## Final Mitigation Plan Monkey Wall Project

**DMS Project #: 100069 | Contract #: 7536 | USACE Action ID: SAW- 2018-01162  
DWR Project #: 20181029 | RFP: 16-007336**

Re: NCIRT Review and USACE Approval of the NCDMS Monkey Wall Mitigation Site / Mitchell Co./ SAW-2018-01162/ NCDMS Project # 100069

**SUBJECT:** Monkey Wall Mitigation Site - NCIRT Comments during 30-day Mitigation Plan Review

Figure 12 - Monitoring Plan  
Monkey Wall Mitigation Project  
Mitchell County, North Carolina

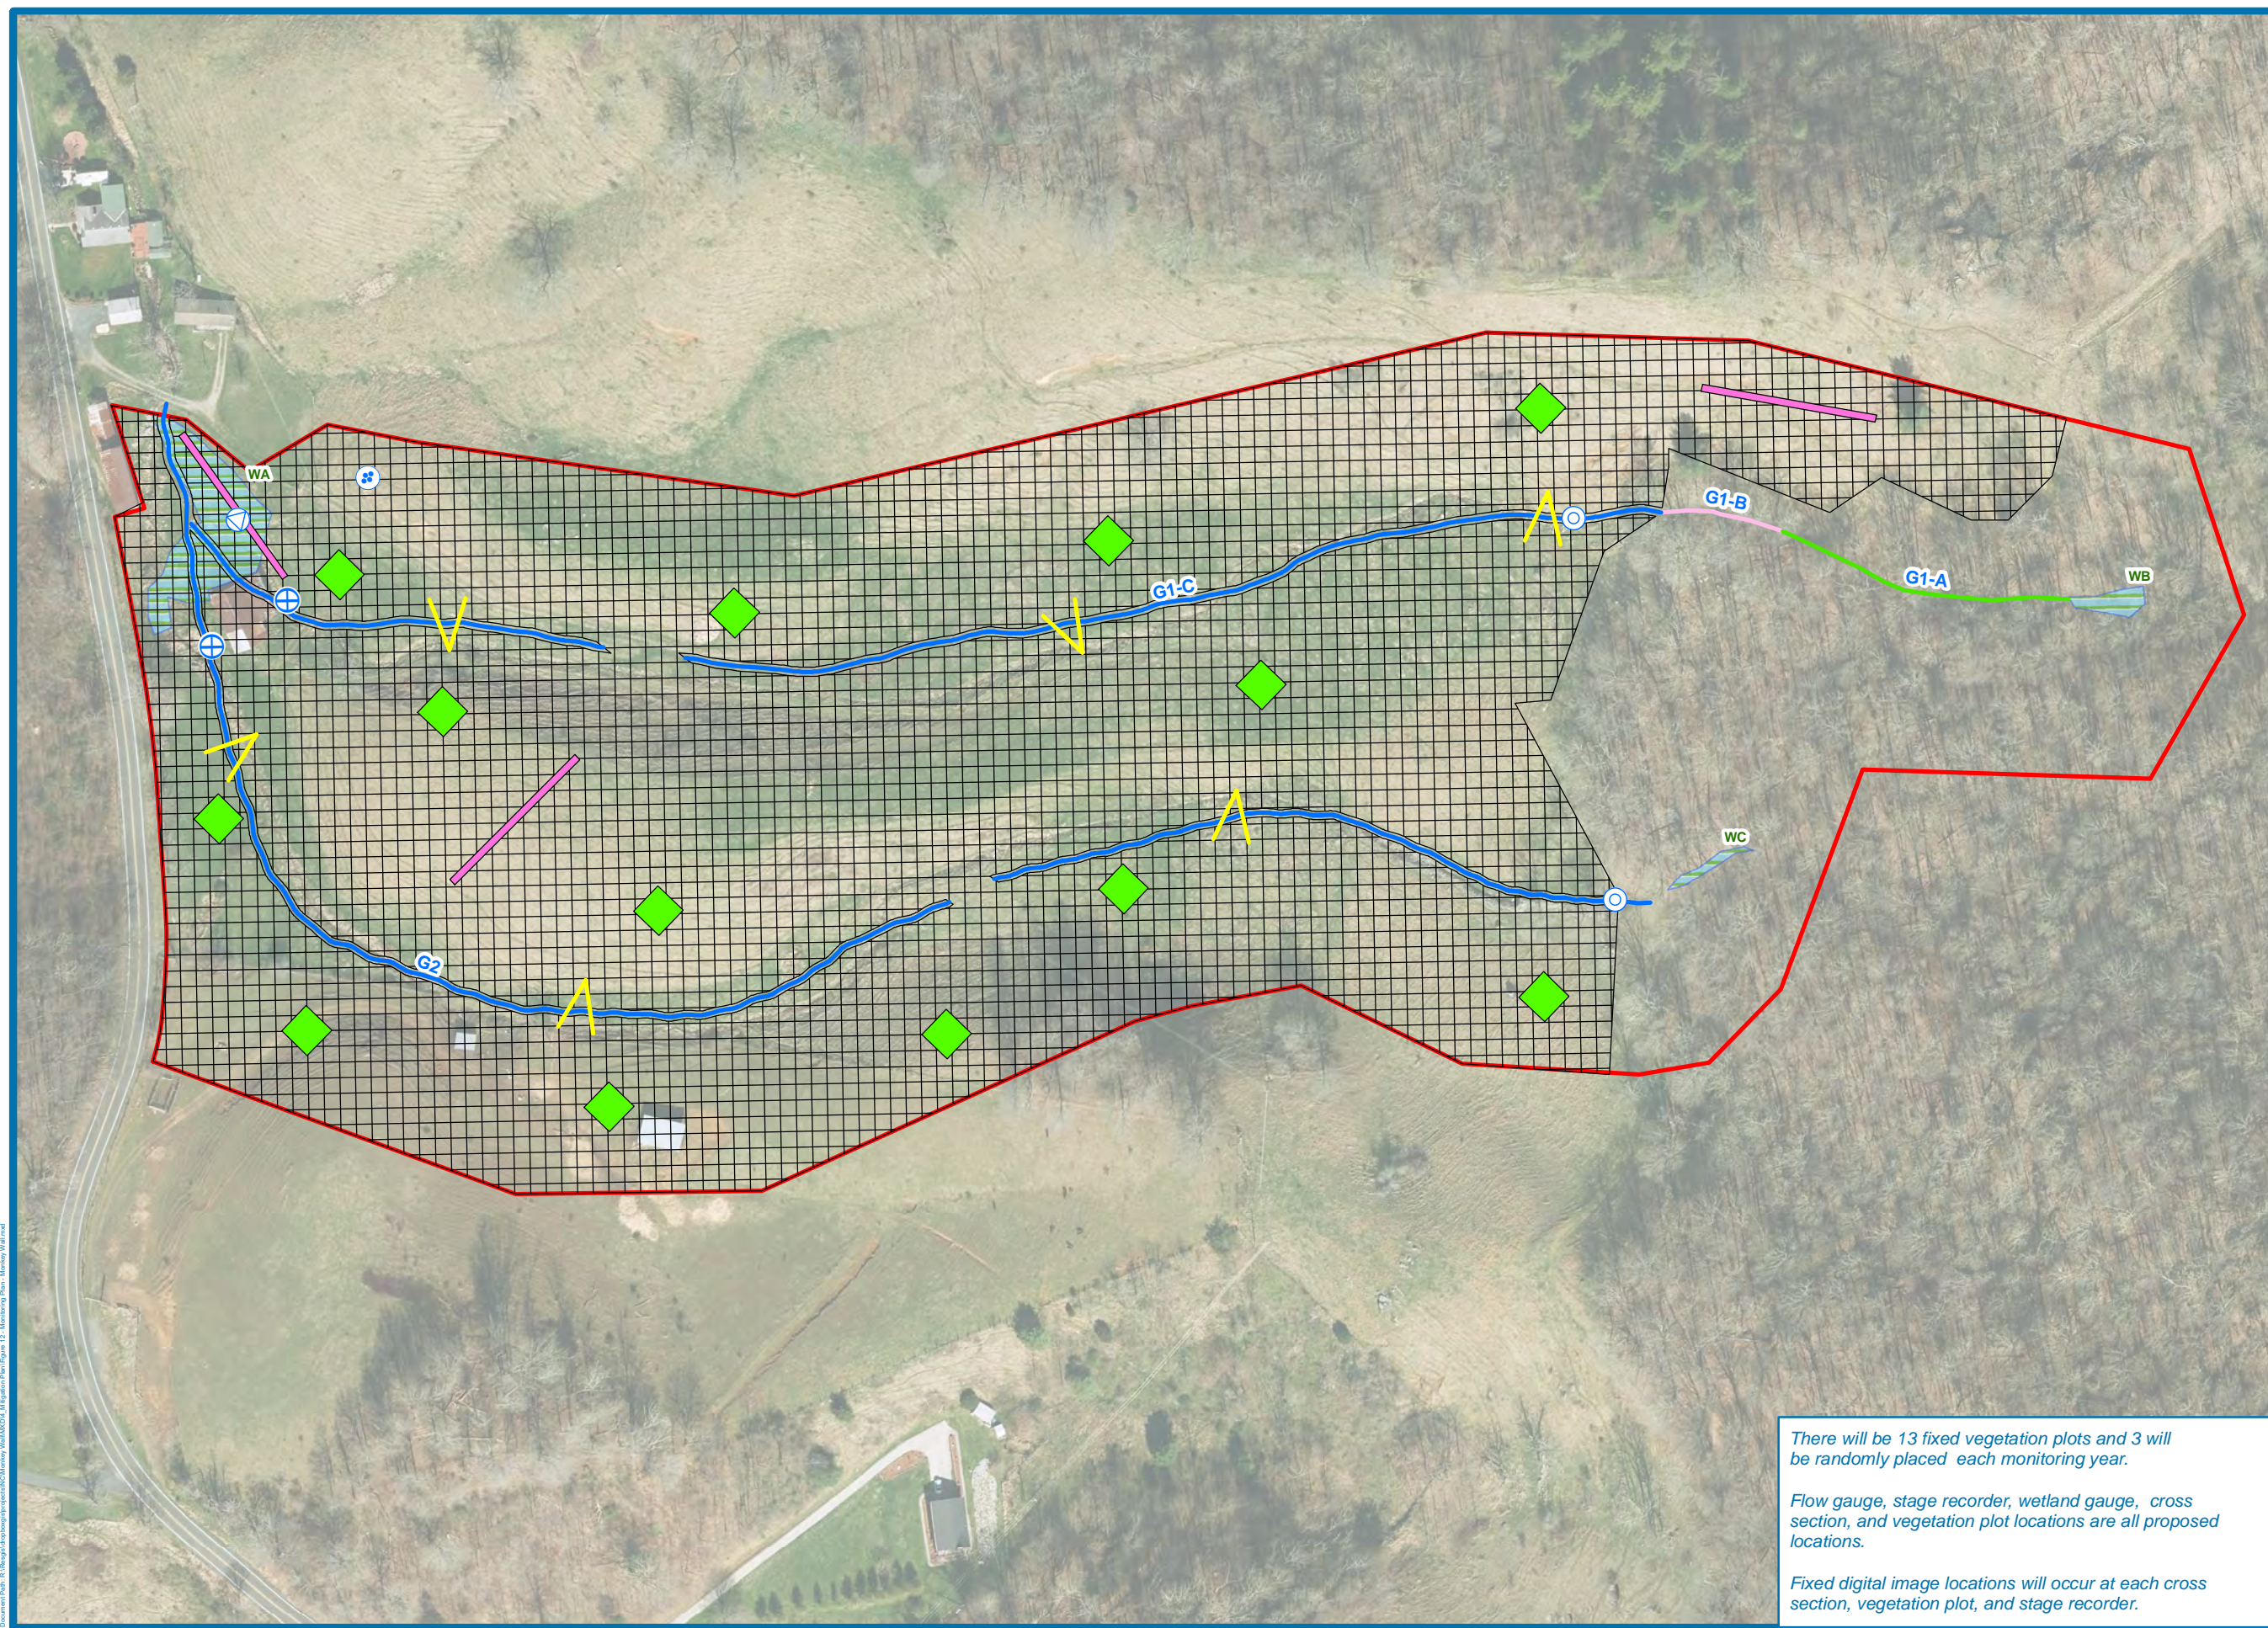
4. Figure 12- DWR likes the planned wetland monitoring gauge in wetland WA.

3. Please place a veg plot in the planted area of WA, random is fine. a. Will FACW species be planted in this area since it was not identified as a different planning zone?  
Figure 12 has been updated to move a random to the planted area of WA, as requested.

**S6**

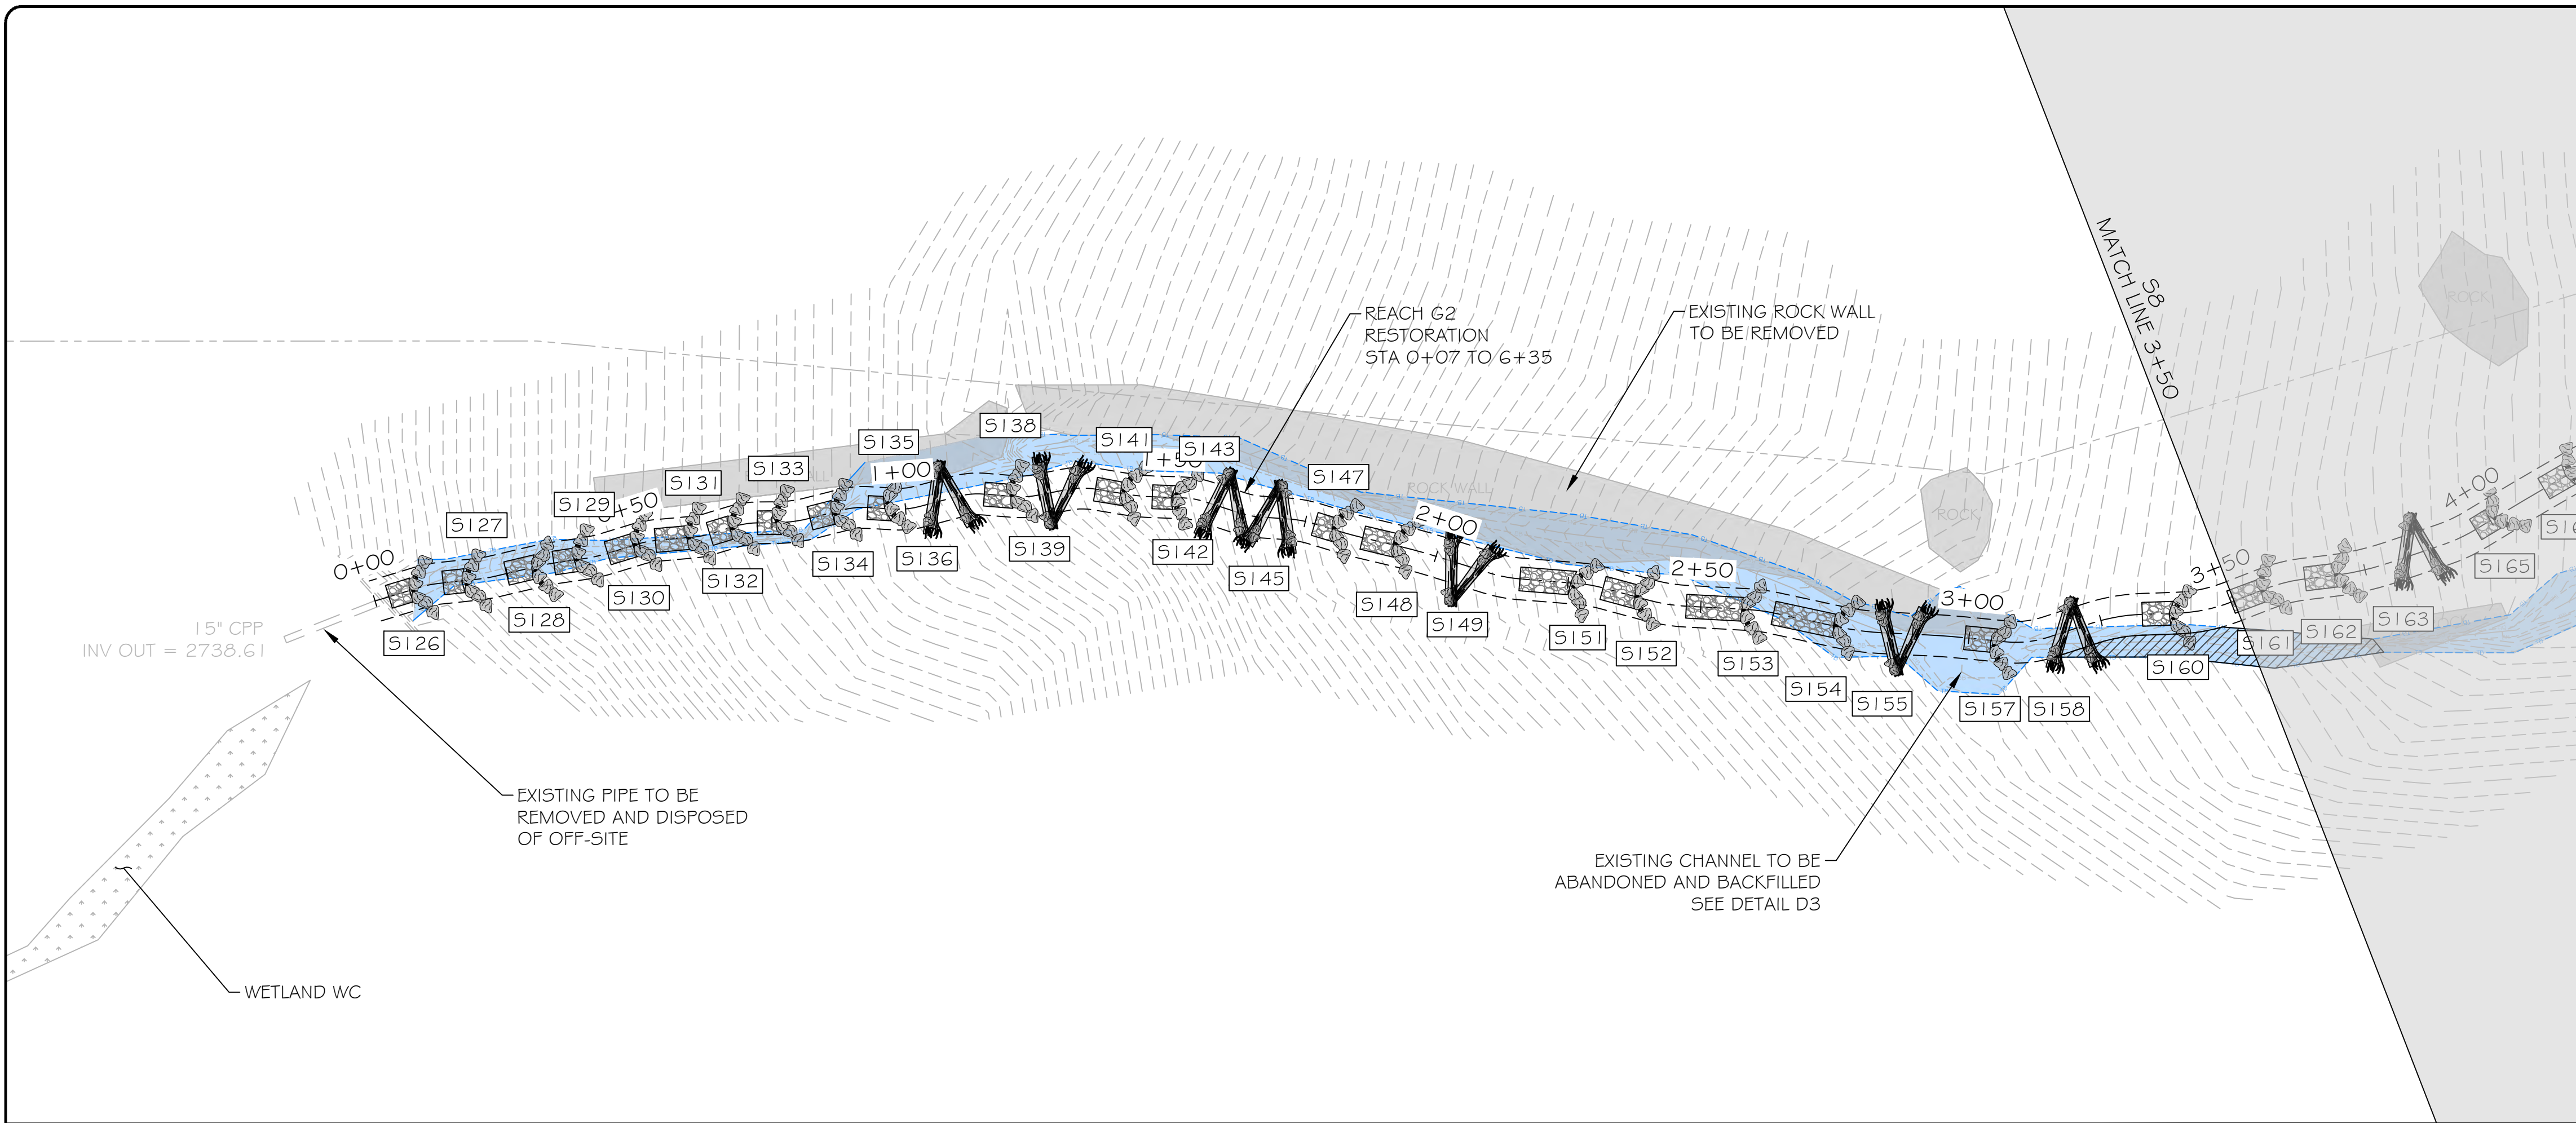
5. Design sheet 6- DWR believes it will be very important to properly fill and pack the relict channel since it is adjacent to the newly constructed channel. In addition, the old channel is downslope from the wetlands and if the channel is not filled correctly, groundwater will be lost through this relic channel and it will essentially be acting like a ditch and drain the adjacent wetlands.

4. Figure 12- DWR likes the planned wetland monitoring gauge in wetland WA.  
RES appreciates this feedback.
5. Design sheet 6- DWR believes it will be very important to properly fill and pack the relic channel since it is adjacent to the newly constructed channel. In addition, the old channel is downslope from the wetlands and if the channel is not filled correctly, groundwater will be lost through this relic channel and it will essentially be acting like a ditch and drain the adjacent wetlands.  
RES appreciates DWR's concern. If the existing channel is filled and plugged per plan, RES does not anticipate any issues with permanent loss of groundwater to the old channel.

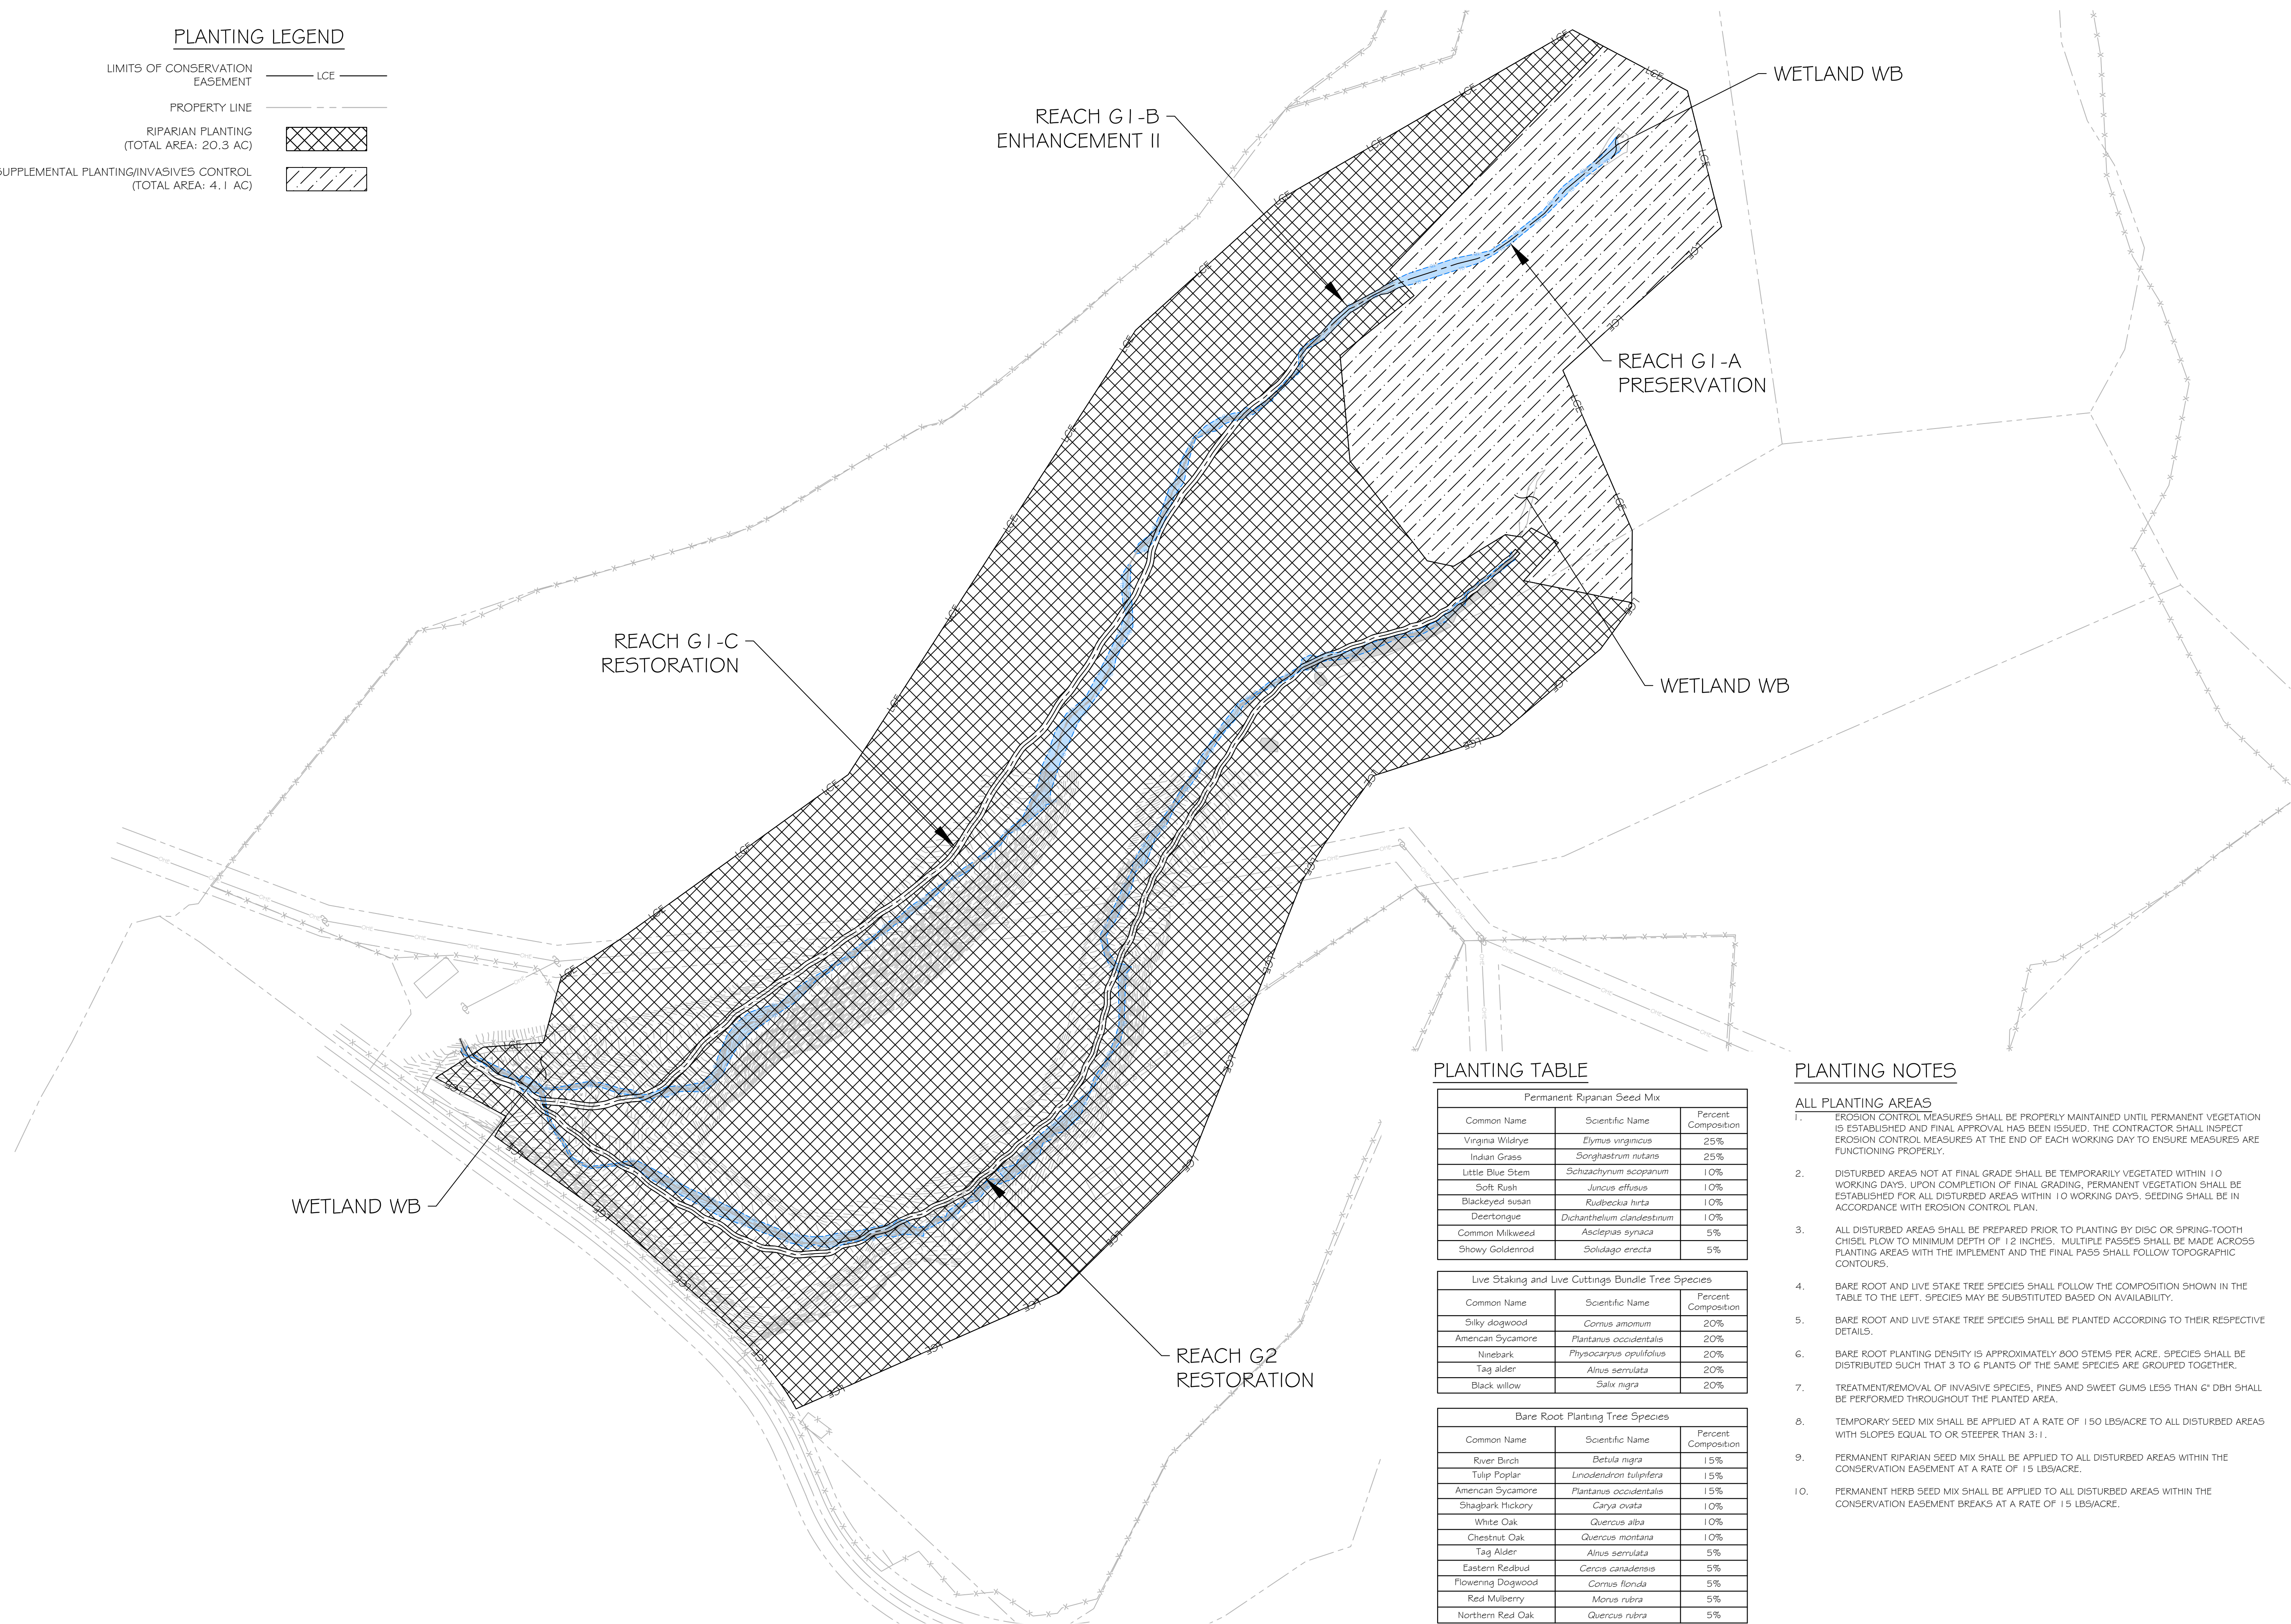
7. Design sheet P1- please limit the Ash planting percentage to 5%. In addition, to make up for the 10% needed DWR recommends that the tree species selected is an appropriate mountain species, something other than Tulip poplar or Sycamore.

7. Design sheet P1- please limit the Ash planting percentage to 5%. In addition, to make up for the 10% needed DWR recommends that the tree species selected is an appropriate mountain species, something other than Tulip poplar or Sycamore.  
RES has revised the planting plan to not include ash and replaced that with additional understory species, as per NCWRC recommendations.
